Conceptual Site Plan

8808 Old Branch Avenue

CSP-24002

SUBJECT: Conceptual Site Plan CSP-24002
Type 1 Tree Conservation Plan TCP1-002-2025
8808 Old Branch Avenue

Figure 1: Conceptual Site Plan

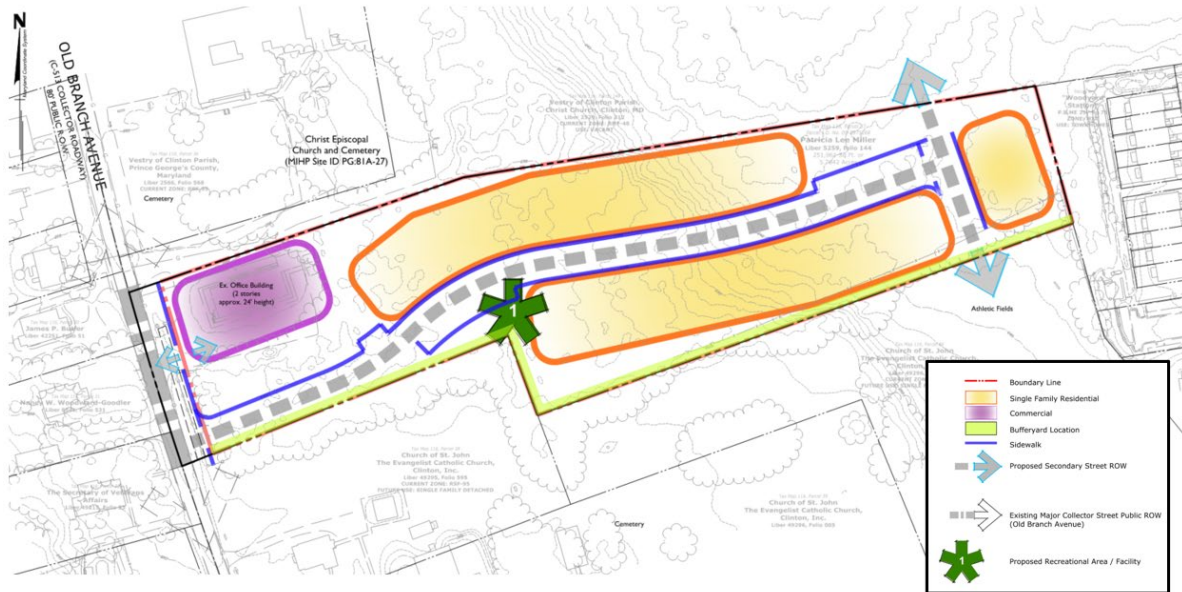
The conceptual circulation plan submitted with this CSP shows sidewalks along Old Branch Avenue and on both sides of one proposed private road, which forms a pedestrian network throughout the site. The submitted plan also shows two vehicle access points on Old Branch Avenue, one of which is for the existing commercial office building and the other will be for the proposed townhouse units. Staff find the conceptual circulation to be sufficient and meets the required findings per Section 27-546(b)(7) of the prior Zoning Ordinance, which examines "physical and functional relationship of the project uses and components" within the M-X-T Zone.

The subject CSP application shows the relationship between residential and non-residential uses within the proposed development and between on-site uses and adjacent uses. The CSP also illustrates approximate locations of the proposed townhouse, the existing office building, and other physical features. The associated plans, including Type 1 Tree Conservation Plan TCP1-002-2025 and Natural Resources Inventory NRI-094-2024, illustrate general grading, woodland conservation areas, preservation of sensitive environmental features, planting, sediment control, and SWM concepts to be employed in any final design for the site. The submitted CSP also shows a potential location of recreational area and an entrance sign. These details will be further evaluated at the time of DSP.

The illustrative rendering shows green area located along the perimeter of the site to provide screening and privacy as well as enhance the physical and visual character of the site. A potential recreational area is located in the center of the property for the proposed residential use. Its location is visible and accessible and will be buffered with landscaping. This requirement will be further evaluated at the time of DSP.

The submitted CSP includes a comprehensive sidewalk network throughout the site to facilitate pedestrian movement. Staff recommend a minimum 10-foot-wide sidewalk and planned bicycle lanes along the property frontage of Old Branch Avenue, in conformance with the MPOT recommendations as described above, to meet the intent of this policy. This will be further evaluated at the time of DSP.

The submitted CSP includes a comprehensive sidewalk network throughout the site to facilitate pedestrian movement. Staff recommend the sidewalk along the property frontage be provided to provide new connections to adjacent properties, which include a school/church. This will be further evaluated at the time of DSP.

- a. A minimum 10-foot-wide sidewalk along the property frontage of Old Branch Avenue unless modified by the permitting agency, in accordance with any Prince George's County Department of Public Works and Transportation adopted standards, or a waiver to said standards approved pursuant to the provisions currently codified in Section 23-105(g)(1) of the Prince George's County Code, with written correspondence.

- b. A standard bicycle lane and signage, in accordance with American Association of State Highway and Transportation Officials guidelines, along the property frontage of Old Branch Avenue unless modified by the permitting agency, in accordance with any Prince George's County Department of Public Works and Transportation adopted standards, or a waiver to said standards approved pursuant to the provisions currently codified in Section 23-105(g)(1) of the Prince George's County Code, with written correspondence.
